# **Superfund Record of Decision:**

## **Combe Fill South Landfill, NJ**

RECORD OF DECISION  
REMEDIAL ALTERNATIVE SELECTION

Site Combe Fill South Landfill, Morris County, New Jersey

Composition of Multi-Layered Cap

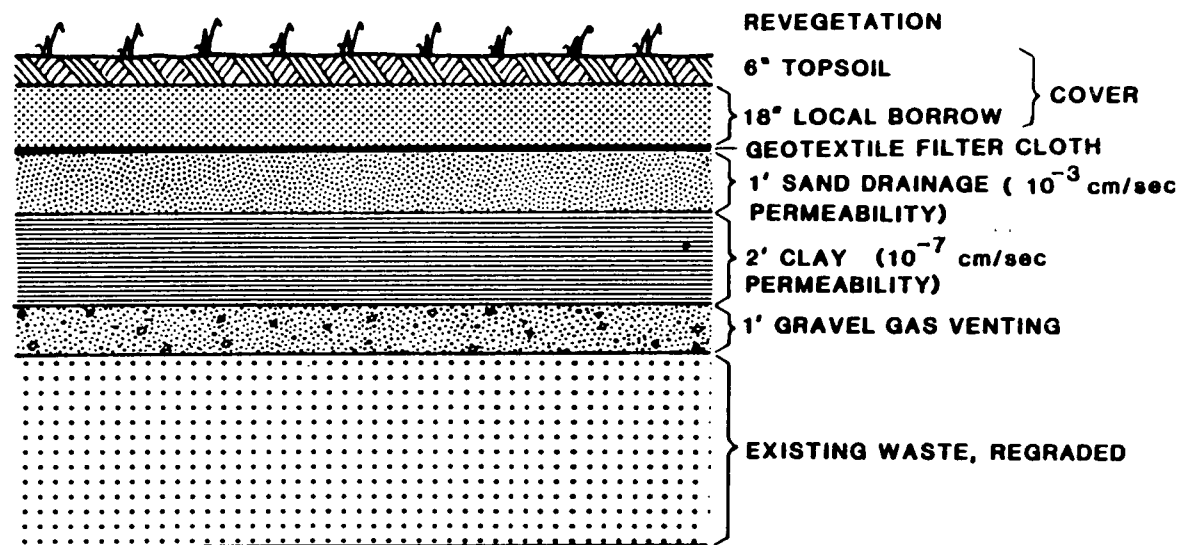
\*Comment: The use of the RCRA multi-layered terraced cap with...a partial membrane cover...exceeds the minimum requirements and adequately reflects site topographic conditions.

Response: The NJDEP concurs with this comment. (The RCRA "model" cap is a multi-layered cap with a plastic liner throughout.)
